Addendum No. 1 for:

WEST DEPTFORD FIRE HOUSE CONVERSION TO A LIBRARY

Architect Project No. 1214A

December 11, 2023

1 FLOOR DEMOLITION PLAN
 A-1.1 SCALE: 1/8" = 1'-0"

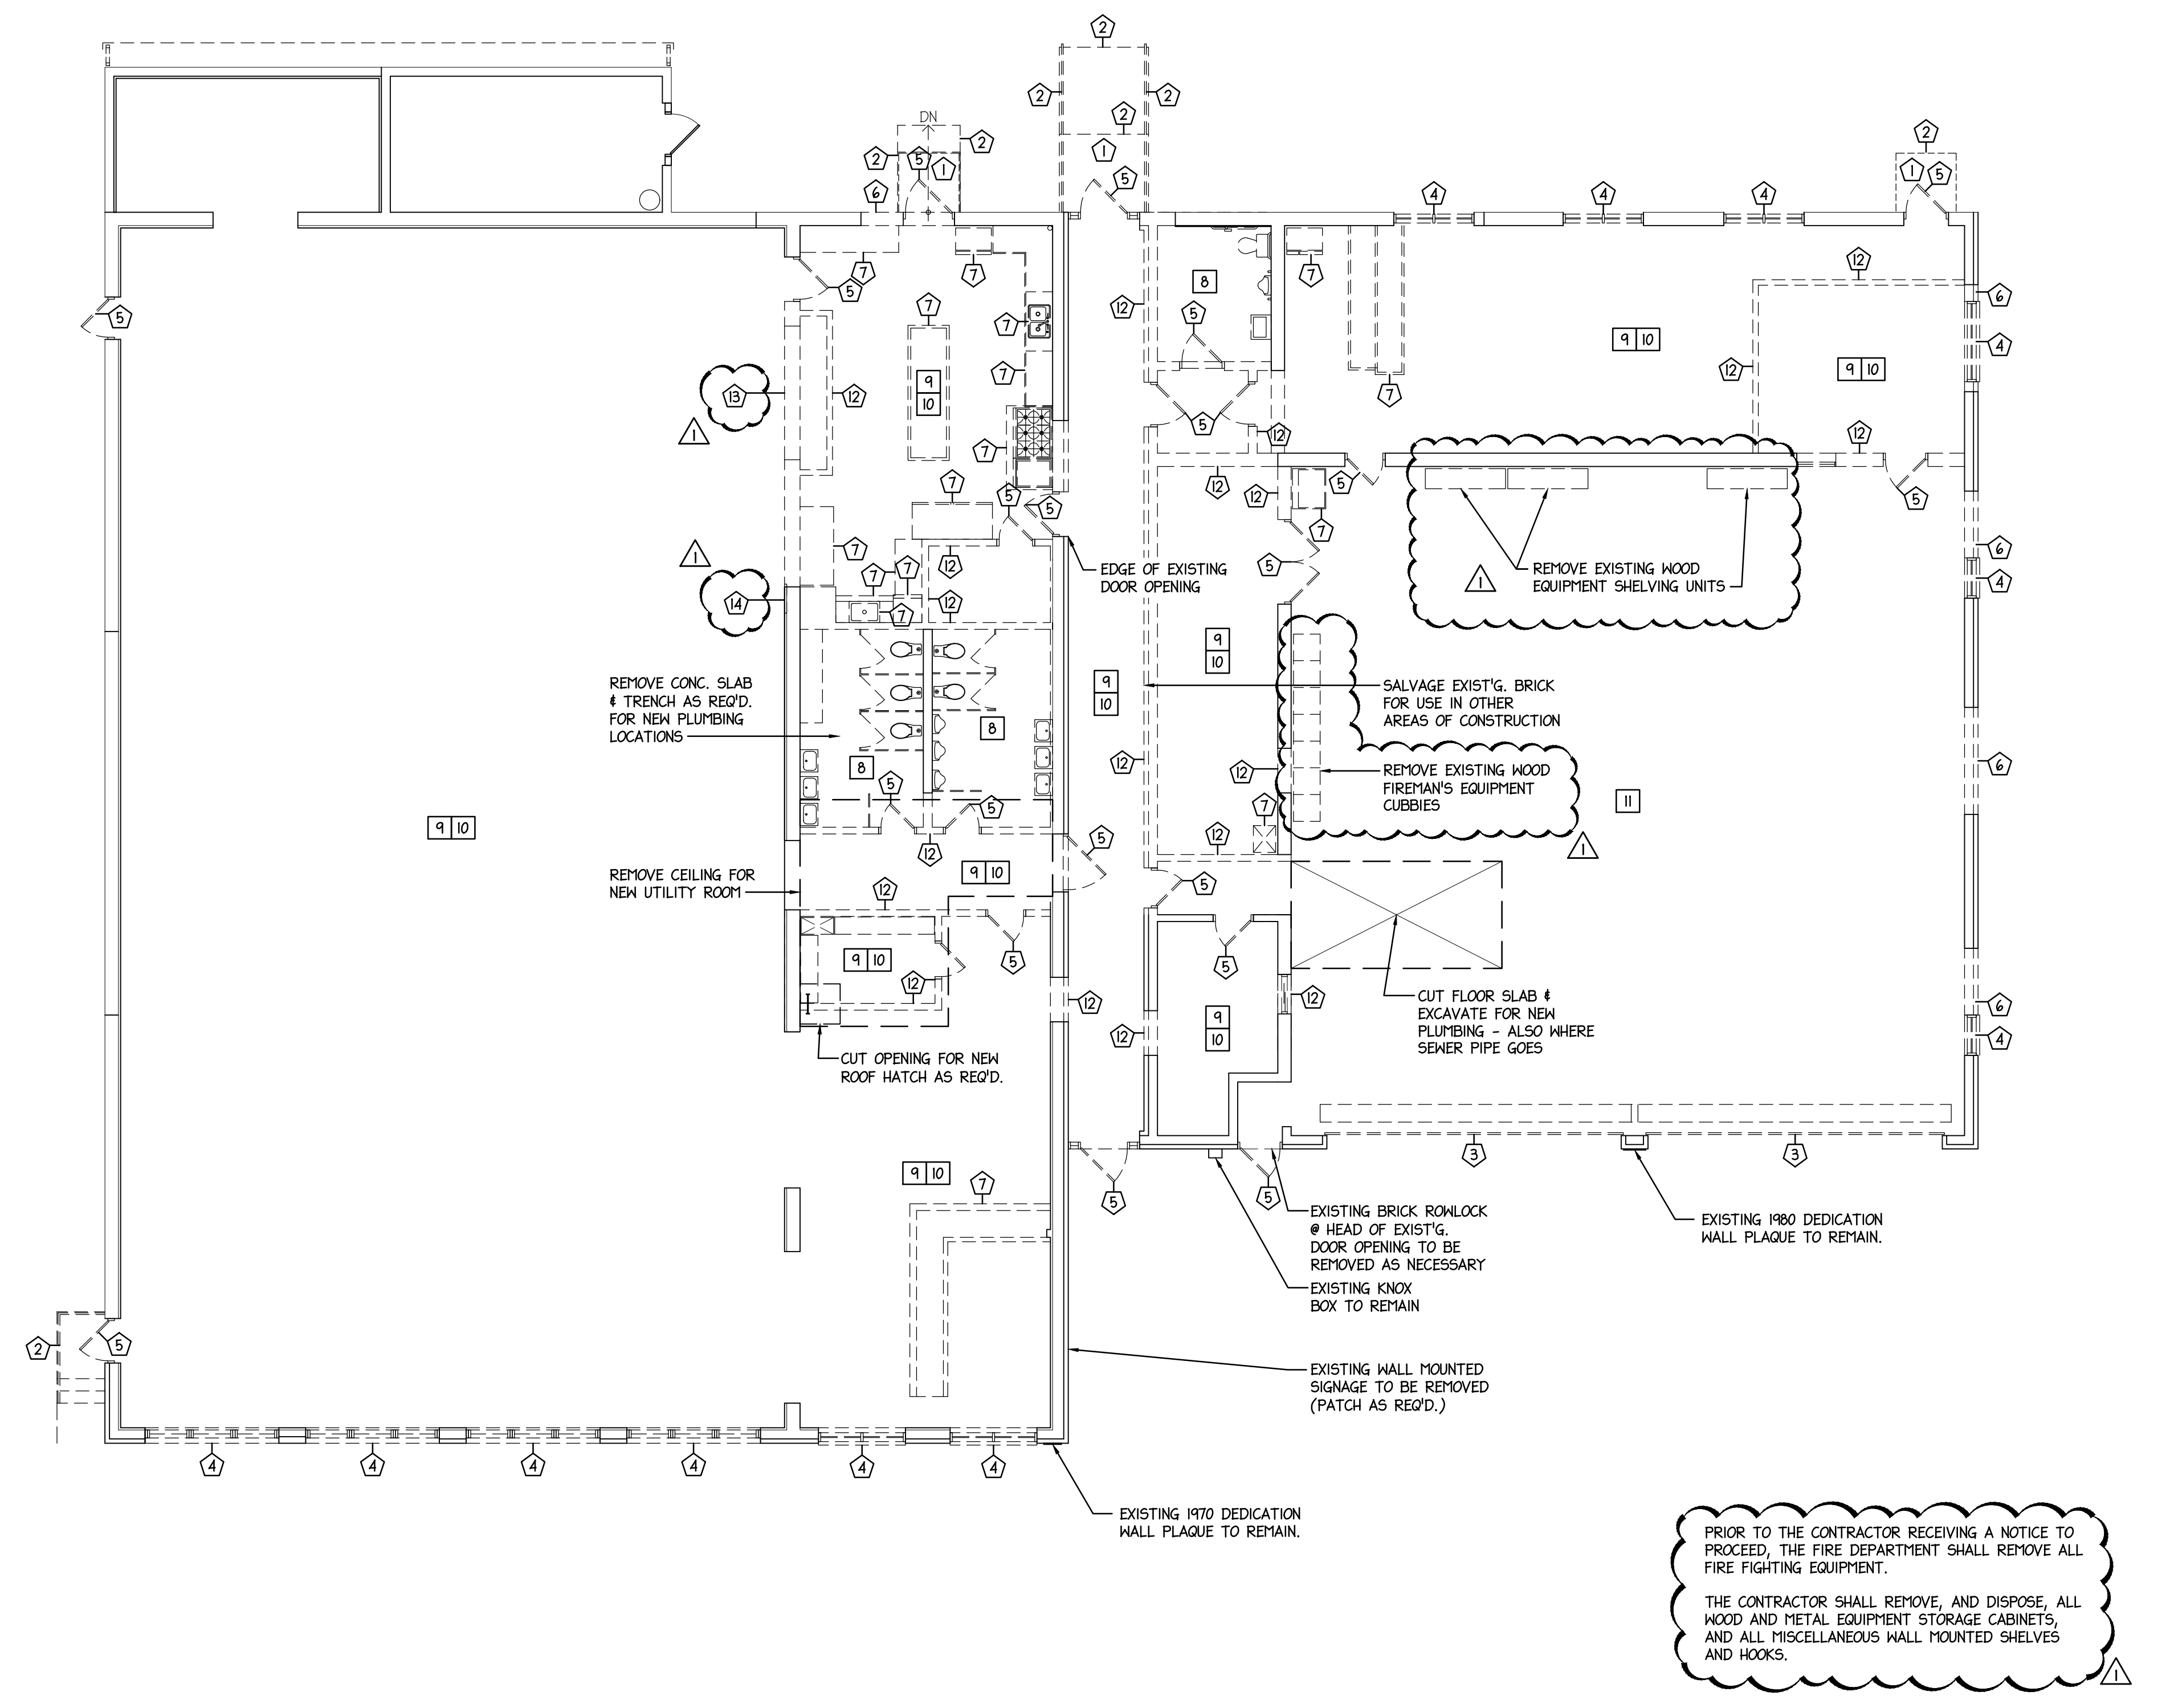
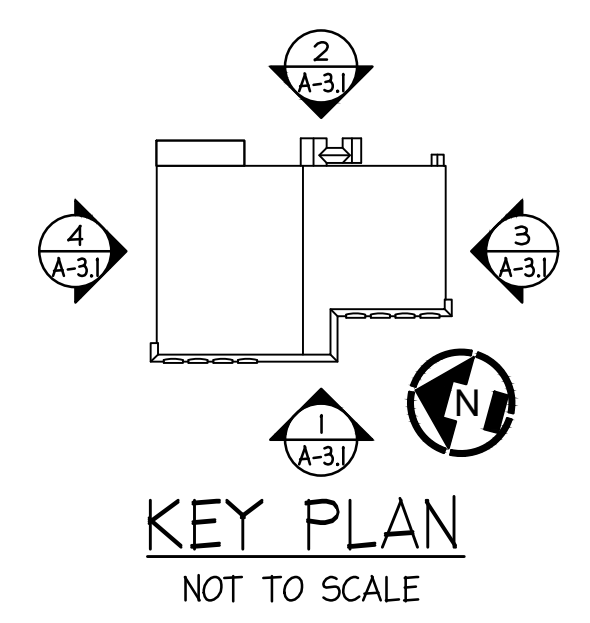
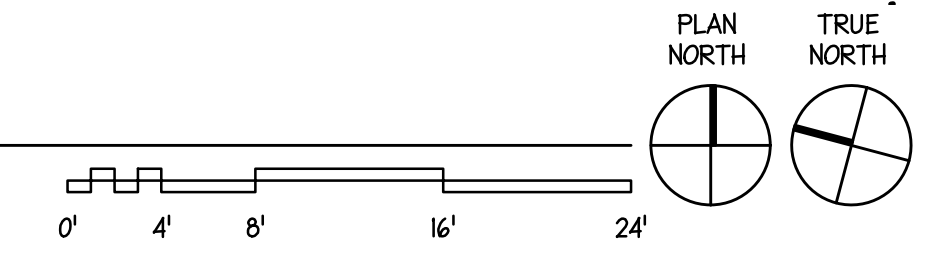
10	On Sheet A-1.1, near the existing Kitchen, two hexagon symbols contain an "X". Please indicate intended demolition note. <i>RESPONSE: Sheet A-1.1 has been revised, with this question addressed.</i>

- A. Drawing Sheet A-1.1 has been modified, with all revisions clouded.
- B. Drawing Sheet A-5.1 has been modified, with all revisions clouded.

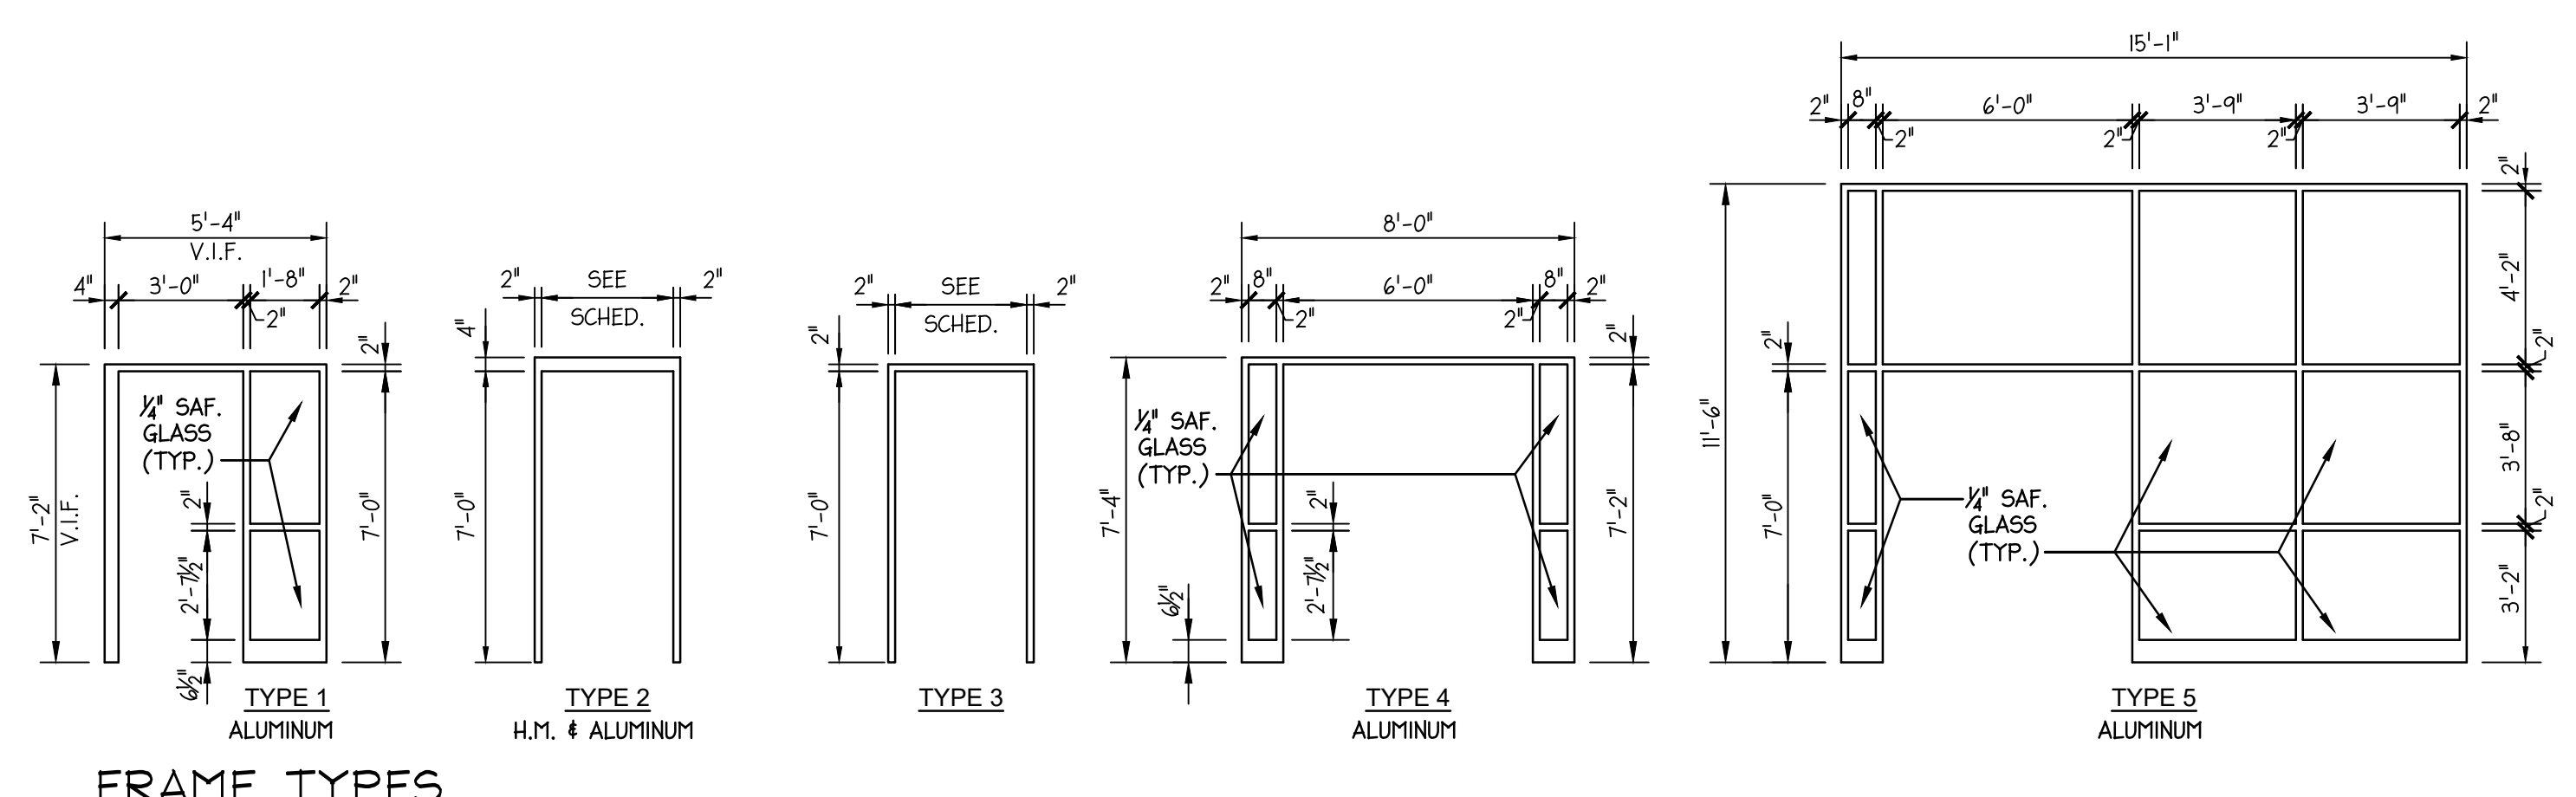
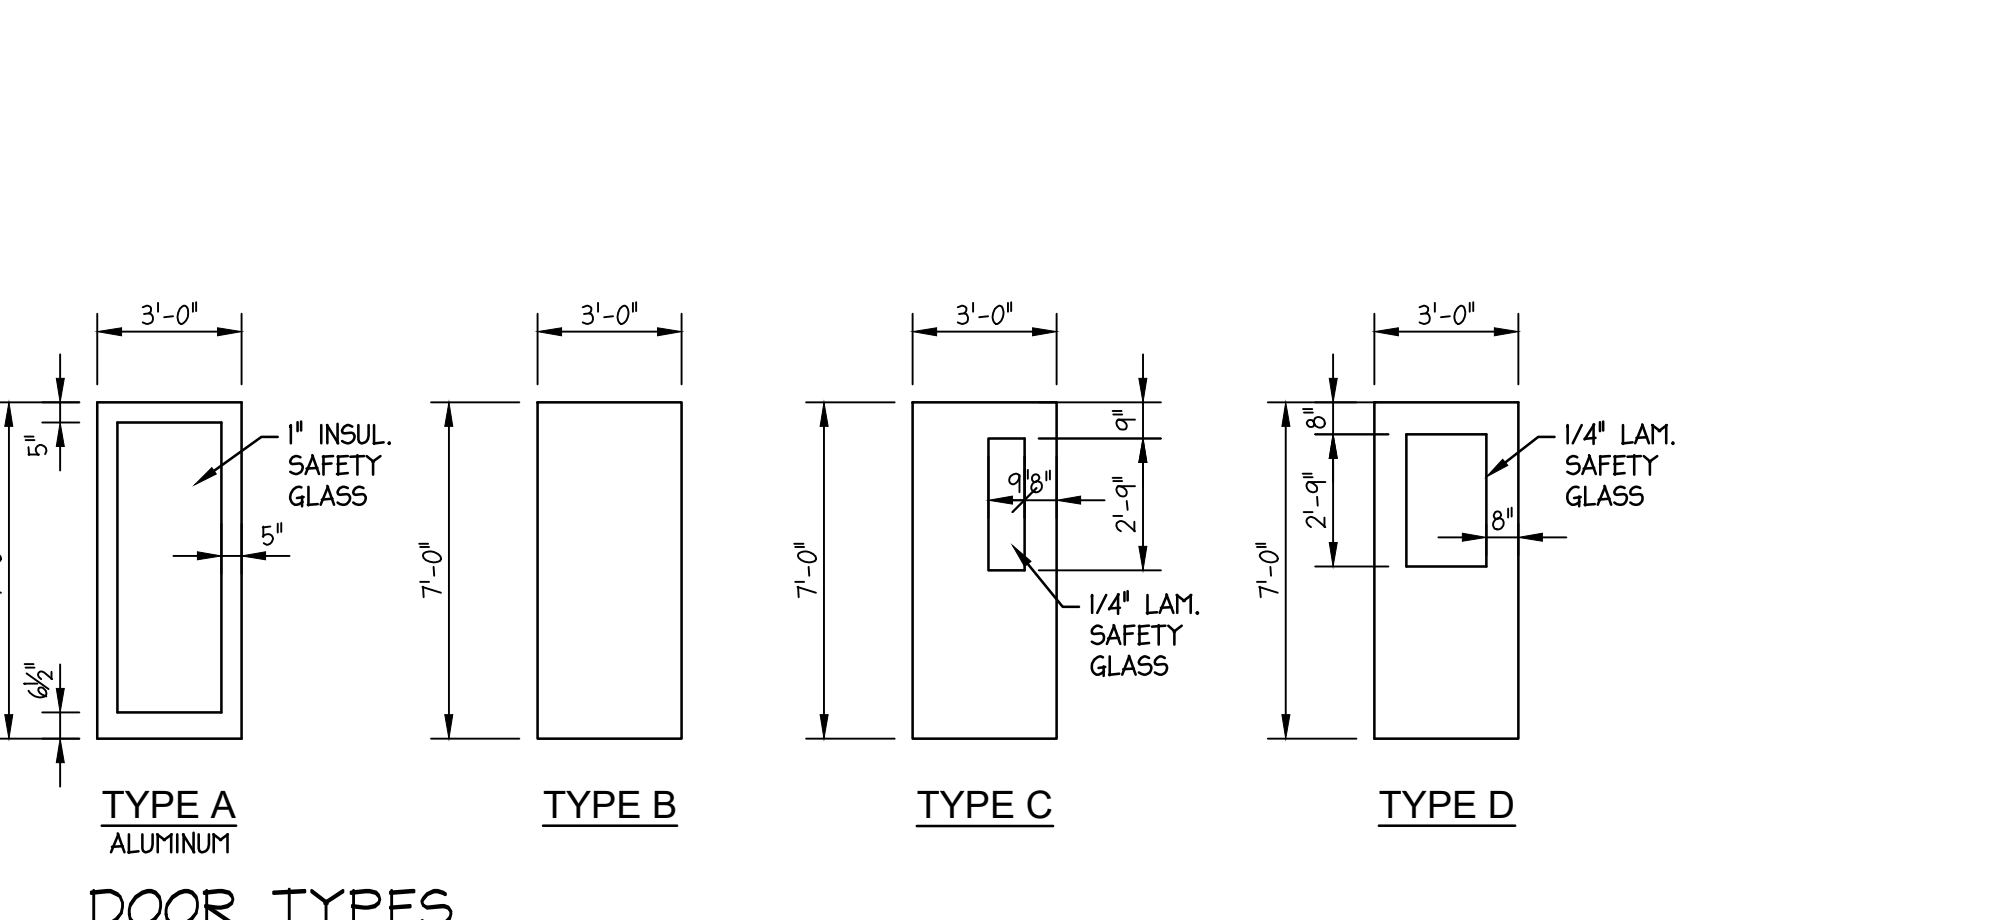
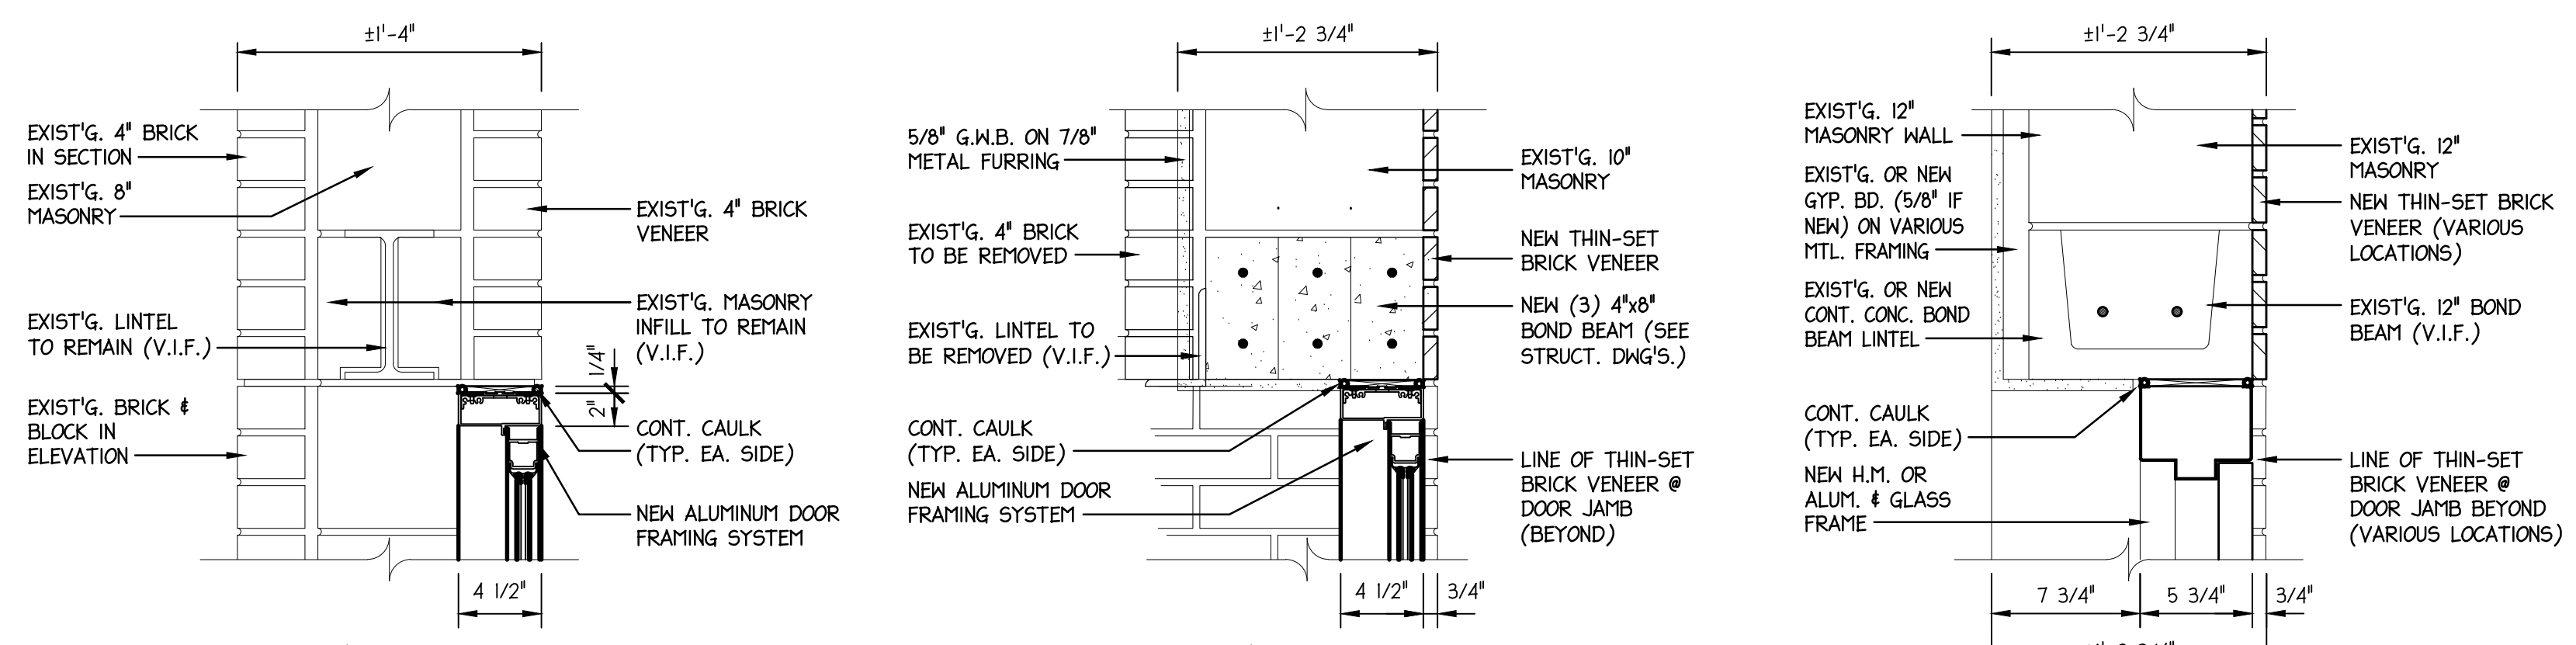
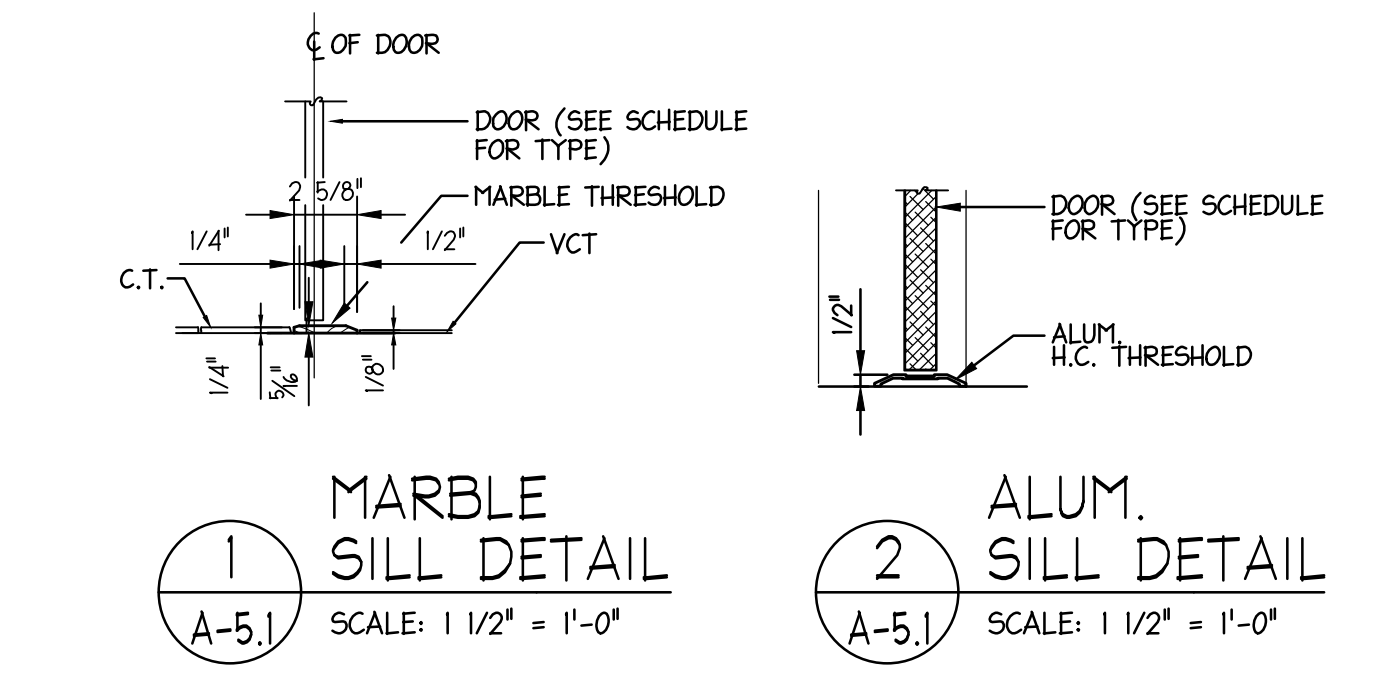
1	The website, from which we obtained notice of this bidding opportunity, identified the Bid Opening Date as December 20, 2023. However, the Specifications identify the Bid Opening Date as December 21, 2023. Which date is correct? <i>RESPONSE: The Bid Opening Date identified in the Specifications is correct.</i>
2	Should the required Bid Bond be 5% or 10%? <i>RESPONSE: The Bid Bond shall be raised to 10 percent.</i>
3	Will the Township waive the permit fees? <i>RESPONSE: Yes, the permit fees will be waived.</i>
4	Regarding the portion of the work associated with the Civil Engineering Drawings, will it be added onto this contract, or will it be a Separate Concurrent Contract? <i>RESPONSE: The Civil Contract shall be a Separate Concurrent Contract.</i>
5	<i>Which company is the current Fire Alarm Vendor? RESPONSE: Vector Security.</i>
6	Can you get some clarity on the basis of design for 20 & 21? HW set is for alum door. But door schedule is calling out as flush hollow metal door. <i>RESPONSE: The Door Schedule erroneously identified the door and frame material. For Doors 20 & 21, the door and frame material has been corrected as Aluminum.</i>
